PRODUCT/PROCESS CHANGE NOTICE (PCN)

PCN #: **TB0803-01** Date: **May 11, 2008**
 Product Affected: **All products shipped in sealed moisture barrier bag.**
 Date Effective: **August 11, 2008**

ATTACHMENT I - PCN #: TB0803-01

PCN Type: Humidity Indicator Card

Fig.1: Photos of the Old and New HIC.

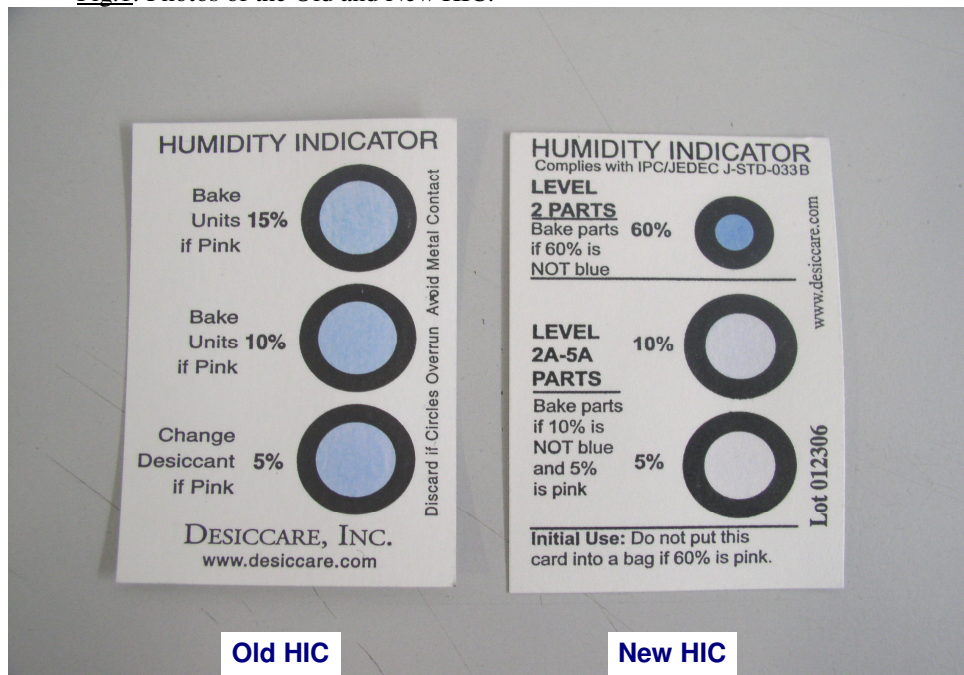
Detail of Change: This notification is to advise our customers that IDT will be changing the Humidity Indicator Card (HIC) to comply with the latest revision of JEDEC standard, J-STD-033B. This change will affect all products shipped in vacuum sealed moisture barrier bag.

Description	Old HIC	New HIC
Supplier	Humipak, Malaysia	Humipak, Malaysia
IDT Part Number	SS-01-10053	SS-01-10125
%RH Indicator	5%, 10%, 15%	5%, 10%, 60%
Bake Condition *	i) 10% RH Indicator turns pink ii) 15% RH Indicator turns pink	i) Both 5% and 10% RH Indicators turn pink ii) 60% indicator turns pink
